United States Patent and Trademark Office

APPLICATION NO.	FILING DAT	re	FIRST NAMED INVENTOR	ATTORNEY DOCKET NO.	CONFIRMATION NO.	
10/709,480	/709,480 05/08/2004		Timothy Kingston	07589.0164.PCUS00 1683		
28694	8694 7590 03/24/2006			EXAM	EXAMINER	
	NOVAK DRUCE & QUIGG, LLP			HO, HA DINH		
1300 EYE S 400 EAST T	TREET NW			ART UNIT	PAPER NUMBER	
	OWER ON, DC 20005			3681

DETAILED ACTION

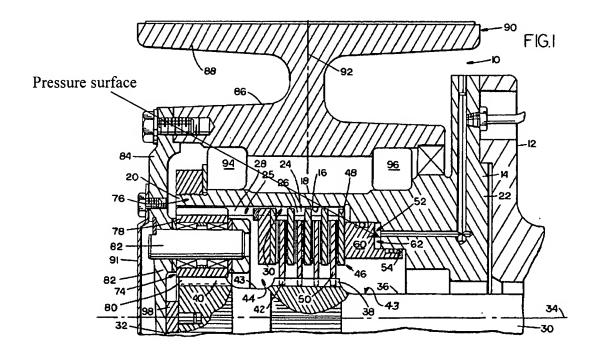
Regarding claim 5, wherein the annular member forms a pressure surface (see the Fig. below) for said braking device.
